# PLANNING & ZONING COMMISSION

**CASE NO**: PZ 16-37

REQUEST: Hold a Public Hearing and forward a recommendation to City Council on the request of Andy

Waggenbach, of Waggenbach Builders, Inc., for a Special Use for Waivers related to landscaping, street wall, setback, and roof material requirements in a Class WH (Warehouse) District, for the property located at 1112-1114 SW Jefferson (Parcel Identification Nos. 18-09-353-023 and 18-09-353-006), Peoria, IL

THRIFT	STORE 1112 SW JEFFERSON	
	SITE LAYOUT PLAN

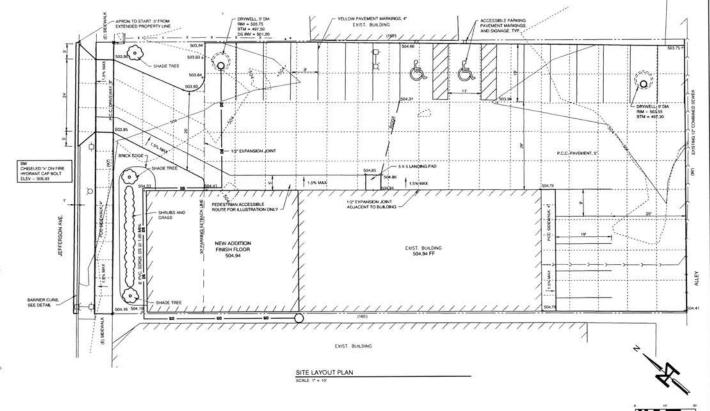
Development Item	Applicant Proposal	Applicant Waiver Request & Justification	SPRB Comment
BUILDING ENVELOPE	STANDARDS		
Height	Per LDC Section 6.5.A.3, the ground story must have at least 12 feet of clear interior height; the drawings show 11.3- 13 feet.	An Administrative Deviation was previously granted per LDC Section 2.4.3., which allows a deviation of up to 10%.	Previously approved.
Siting – required building line	Per LDC Section 6.5.C.16, the building must be either: built to the required building line (no setback from the front property line); or a street wall must be provided.	Waiver requested; site plan provides landscaping in lieu of the wall.	No objection.
Siting – minimum continuous open area	Per LDC Section 6.5.C.10.b, a 15% minimum continuous open area is required.	An administrative waiver was previously granted per LDC Section 10.5.3.	Previously approved.
Elements	Per LDC Section 6.5.D.1.b, windows and doors on the	None	Final submittal must include dimensions to

Development Item	Applicant Proposal	Applicant Waiver Request & Justification	SPRB Comment
	ground story facades shall comprise at least 20%, but not more than 80%, of the façade area; and a functioning entry door shall be provided along the ground story at intervals not greater than 75 linear feet.		indicate how both of these requirements are met. Additionally, windows may not be covered by boards; existing boarded windows must be uncovered.
Use	Warehouse and Sales	N/A	Change of occupancy requires applicable building permits.
ARCHITECTURAL STA	ANDADDO		
Roofs and Parapets	Per LDC Section 6.6.2.B.4, metal roofs must be standing seam, equivalent, or better.	Waiver requested. Applicant states existing roof is a ribbed, steel roof; standing seam is not compatible.	No objection with conditions.
Street and Garden Walls – unbuilt building line	Per LDC Section 6.5.A.14, a street wall is required along the unbuilt building line within 8 inches of the front property line, and must be 6 -8 feet in height.	Waiver requested.	No objection with conditions.

Street and Garden Walls - materials	Per LDC Section 6.6.6, materials may consist of native/regional stone and equivalent imitation stone, metal, brick, stucco, or a combination. Stone or brick pillars shall be used at intervals of 8 – 10 feet to avoid long, uninterrupted, horizontal street walls.	N/A if waiver of requirement to provide the wall is approved.	N/A
Street and Garden	Per Section 6.5.D.4, the maximum width of a vehicle entry gate allowed is 18 feet. Note the gate and the approach are separate requirements; not the same.	N/A	Per the Fire Department, the access of 18' in width is acceptable if existing access; if a new entrance must be constructed, it shall be a minimum of 20' wide.
Walls – vehicle entry gate			Per Public Works, final site plan must show proposed curb replacement. The proposed driveway as shown (24 feet wide minimum with 5-feet wide aprons) is acceptable; a nd apron may not cross

Development Item	Applicant Proposal	Applicant Waiver Request & Justification	SPRB Comment
			the property line as extended to the curb. Additionally, a pedestrian accessible route (PAR) shall be provided between the public ROW and the building.
Exterior Building Materials	Metal must be wrought iron, welded steel and/or aluminum [electro-statically plated black].	Not requested; applicant agrees to comply.	Must demonstrate compliance.
Signage	Was not submitted with this application.	None	All signage, existing and proposed must be meet code, including LDC Section 6.6.8; and have a permit. Any existing sign without a permit requires a permit, or to be removed if not lawful. Bubble awnings and free standing signs are not permitted (neither existing nor proposed); and may not be located on the site.
Mechanical Equipment	Not shown.	None.	Must meet Code.

The Site Plan Review Board recommends APPROVAL of the request, with the following waivers and conditions:

- 1. Roof type—Wavier from LDC Section 6.6.2.B.4, metal roofs to allow a non-standing seam, ribbed steal roof.
- 2. Street Wall LDC Section 6.5.A.14, waiver of requirement to provide a street wall along the unbuilt building line within 8 inches of the front property line, parallel to the building addition.

- 1. Prior to construction, final Site Plan Review Board approval is required. The application must include a lighting plan and all required submittals.
- 2. Landscaping must be provided as indicated on the site plan.
- 3. All applicable permits must be obtained.
